**STAFF REPORT  
FOR THE HISTORIC REVIEW BOARD**

**FILE NUMBER:** DR-11-02

**REQUEST:** Rear addition and detached garage

The applicant is proposing a detached garage and a 195 square foot rear addition to the house at 1608 6<sup>th</sup> Avenue. The project is subject to the criteria in Chapter 25, Historic District, in the City's Community Development Code (CDC).

**SITE DEVELOPMENT PLAN**

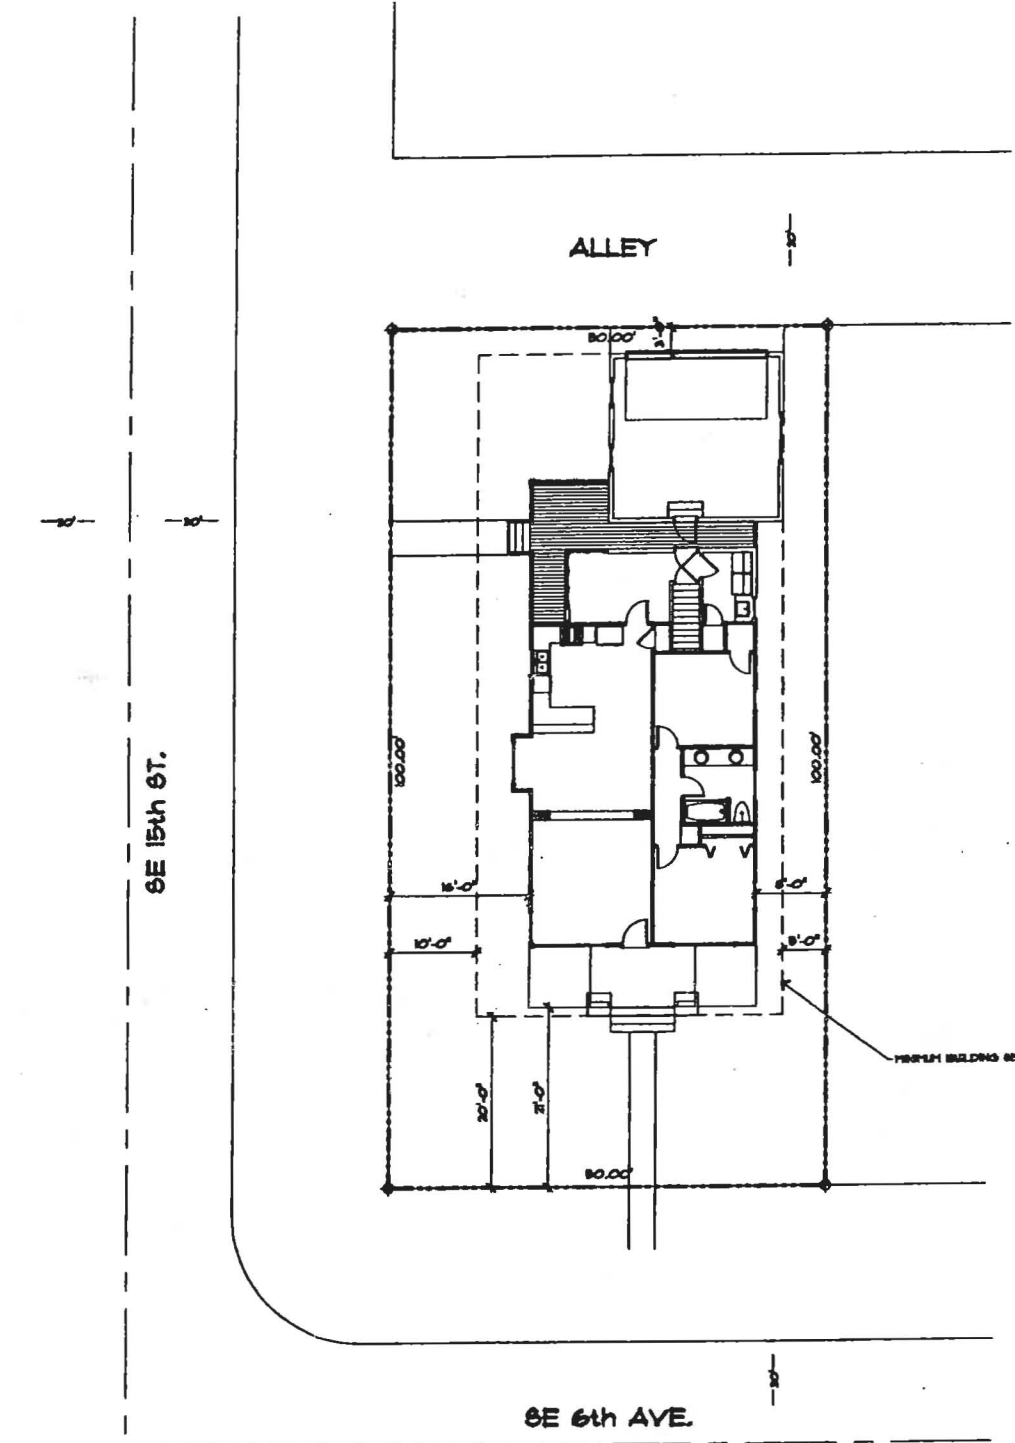
**FINDING NO. 2:** The proposed addition complies with the required setbacks and lot coverage. The orientation provision (5) does not apply. Five feet is the required side yard setback and the proposed addition has a setback of 8'. The proposed addition has a side street setback of 20' for the rear addition, which exceeds the 10' that is required. The proposed lot coverage of 38.36 percent is less than the 50 percent maximum that is permitted in the historic district. The criteria are met.

**FINDING NO. 3:** The proposed garage complies with the garage standards. It is accessed from the alley and will have wood siding with the same profile as the existing siding on the residence. The roof pitch of 6:12 is the same as the residence. This pitch is appropriate for the architectural type. The garage has a 5' side yard setback and a 3' rear yard setback, which is in excess or equal to the required setbacks. The criteria are met.

SHEET TITLE: BUILDING ELEVATIONS  
 SCALE: 1/4" = 1'-0"

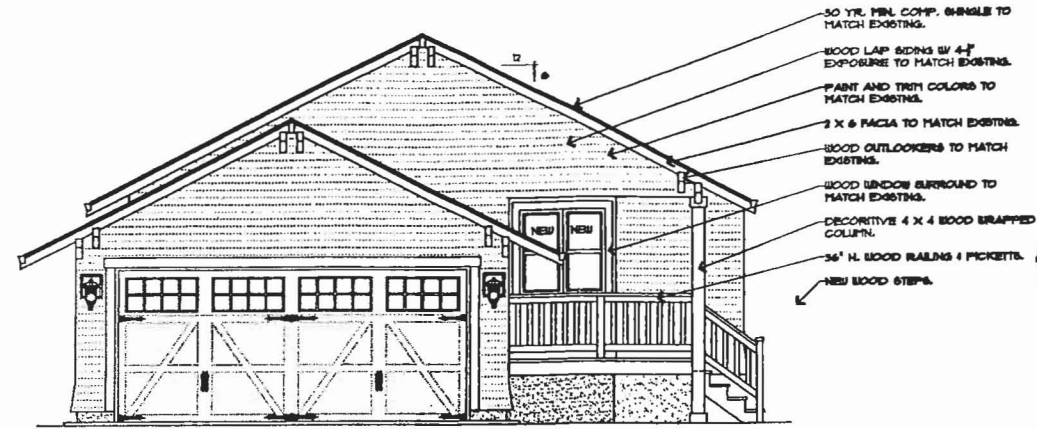
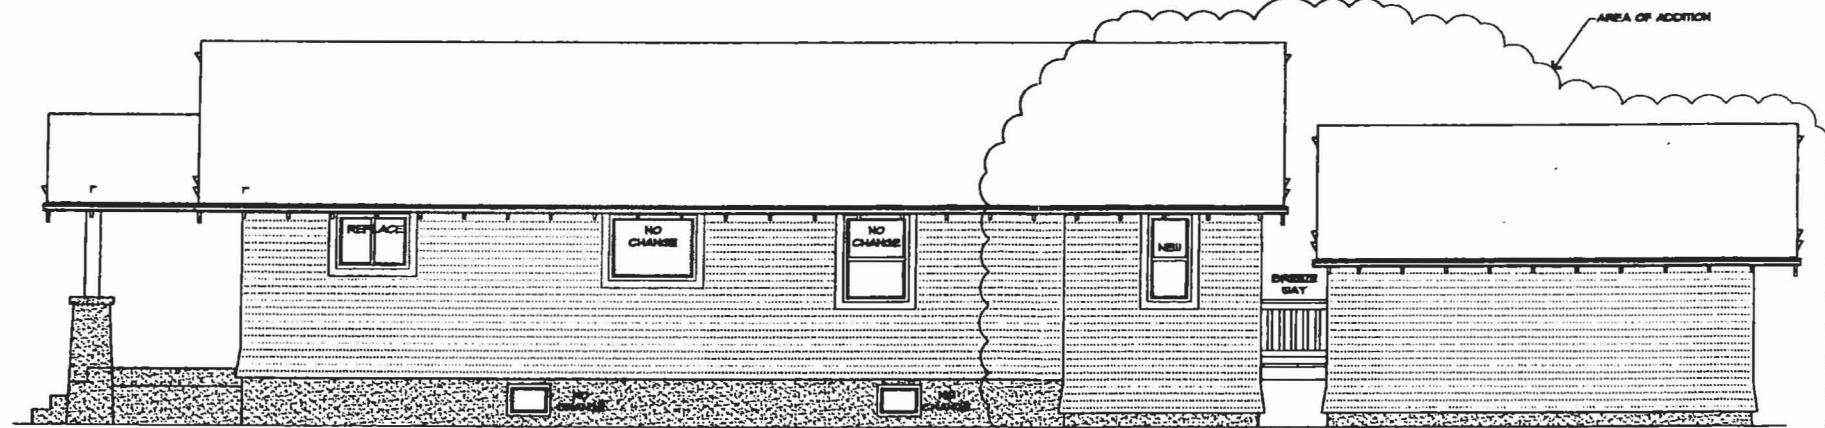
**FINDING NO. 4:** The proposed rear addition will maintain the existing roof height of 18' above grade. The garage will be 14'. The rear addition is set back from the 15<sup>th</sup> Street side façade. The proposed alterations will not compromise the character of the front elevation and will not significantly modify the mass of the house as seen from the right-of-way. The criteria are met.

**FINDING NO. 8:** The applicant is proposing replacing the existing aluminum windows with 1/1 wood windows. On the front elevation, the applicant will replace the existing aluminum window on the left with a grouping of three windows in a manner similar to that of the historic photo. However, the applicant is maintaining the enlarged opening on the left and the smaller opening on the right rather than restoring them to their historic appearance. On the remainder of the elevations, the applicant will maintain the existing opening sizes and replace the existing aluminum windows with wood windows. Staff's preference is for the opening size to be restored to its original appearance. However, the applicant is increasing the integrity of the structure by replacing the aluminum windows with wood windows and is not altering the opening size of the existing windows. The criteria are met.

**FINDING NO. 11:** The proposed roof is 6:12, which is less than the required 8:12. However, the existing roof is 6:12 and this pitch is compatible with the architectural type. The proposed roof is asphalt composition shingle and will match the existing roof. The criteria are met.

**MAIN LEVEL FLOOR PLAN**  
SCALE: 1/4" = 1'-0"

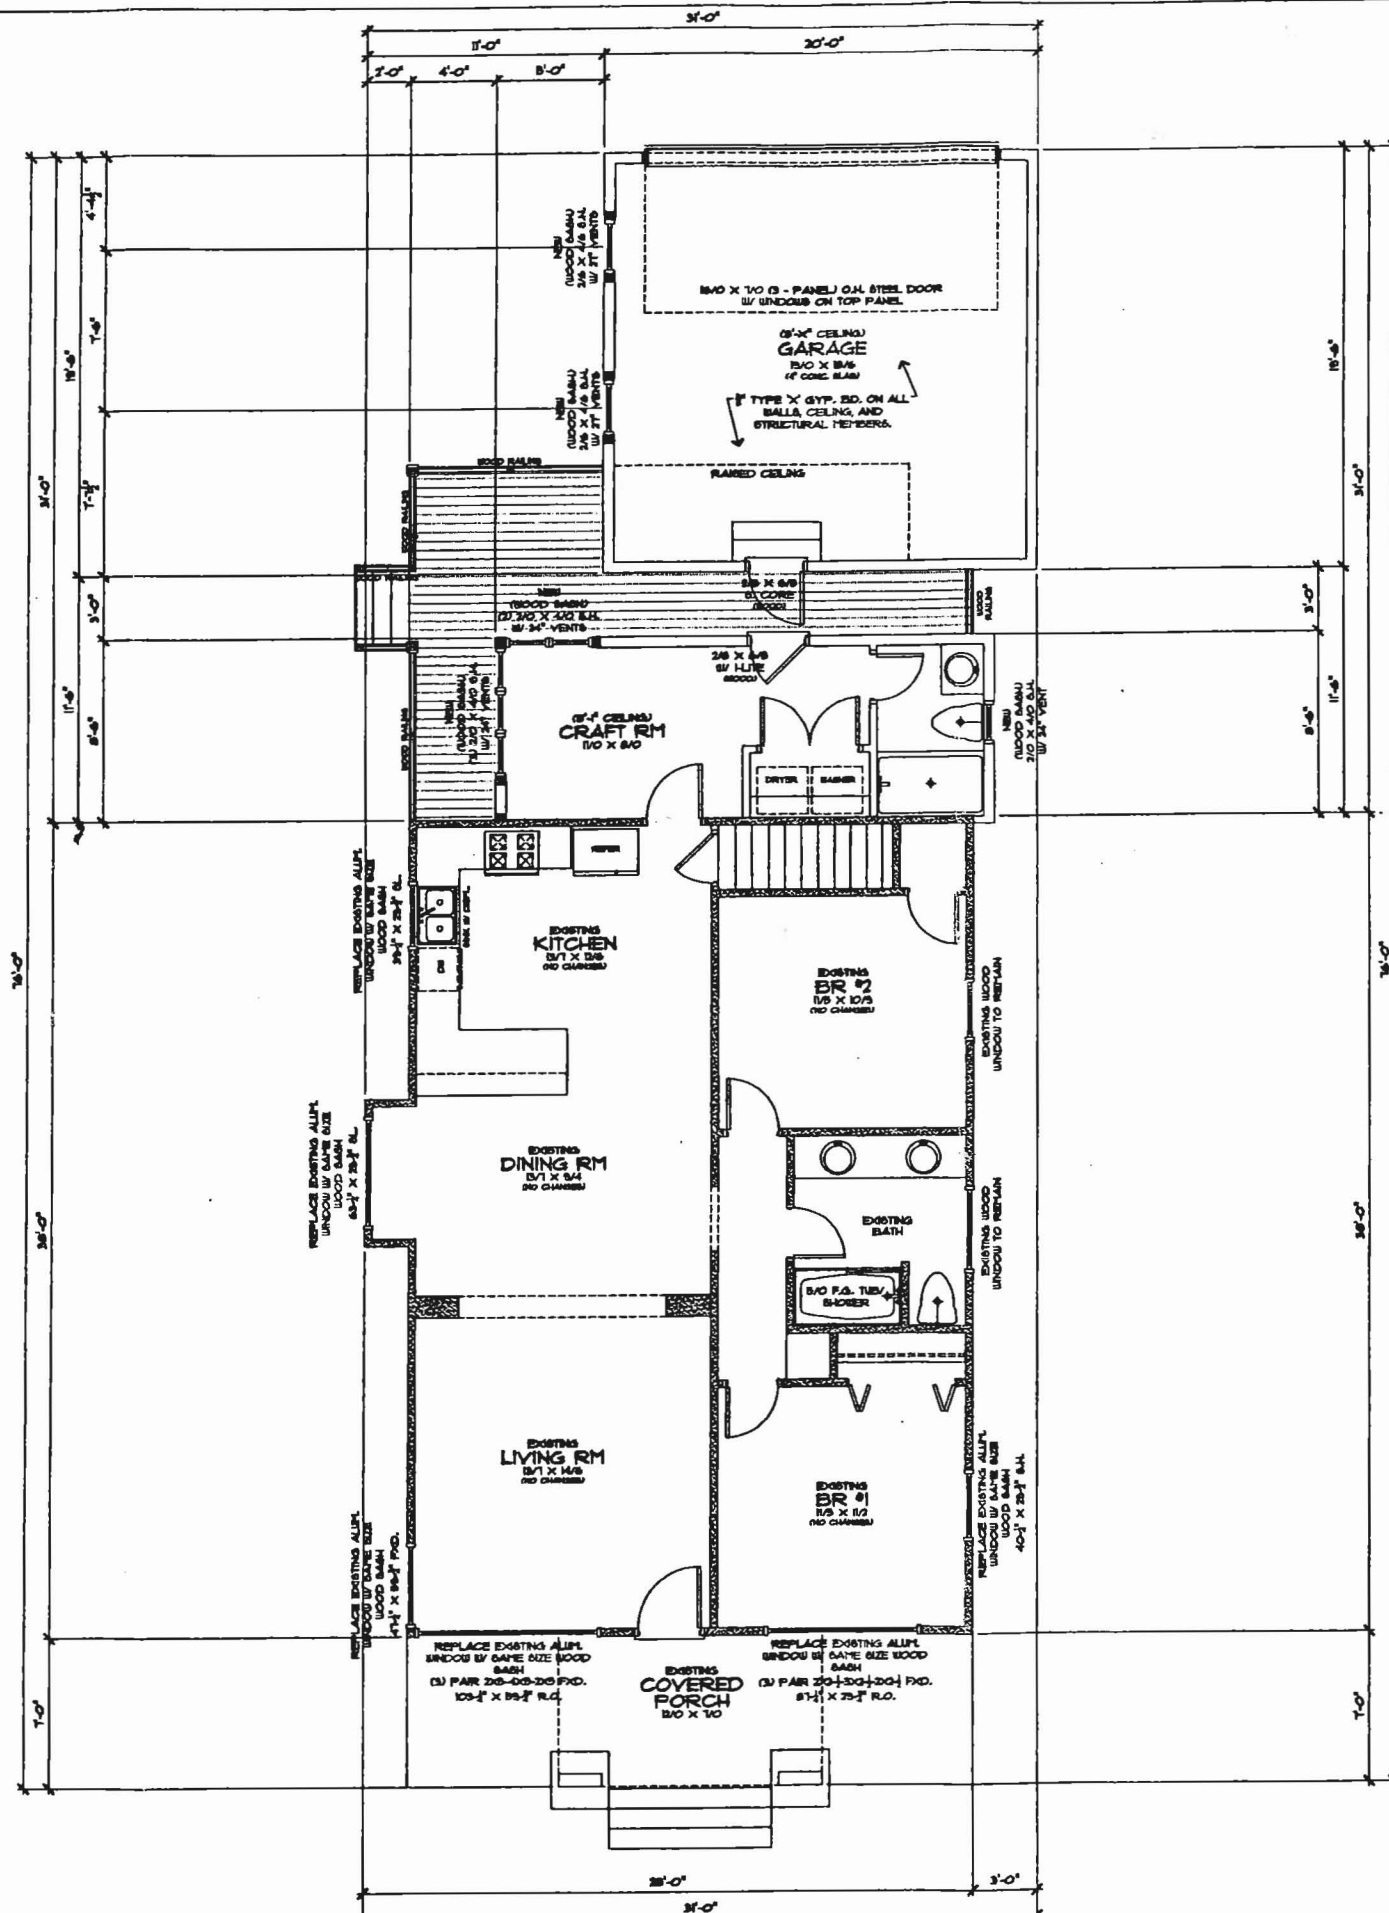
**FINDING NO. 12:** The proposed 195 square foot addition increases the square footage of the residence to 1,197 square feet. Since the property is a corner lot, only the square footage of the single adjacent residence to the east is used in the calculation to determine the maximum square footage. Per the Clackamas County Assessor's Office, the adjacent property is 1,015 square feet. Therefore, 125 percent of this is 1,269 square feet. The criterion is met.
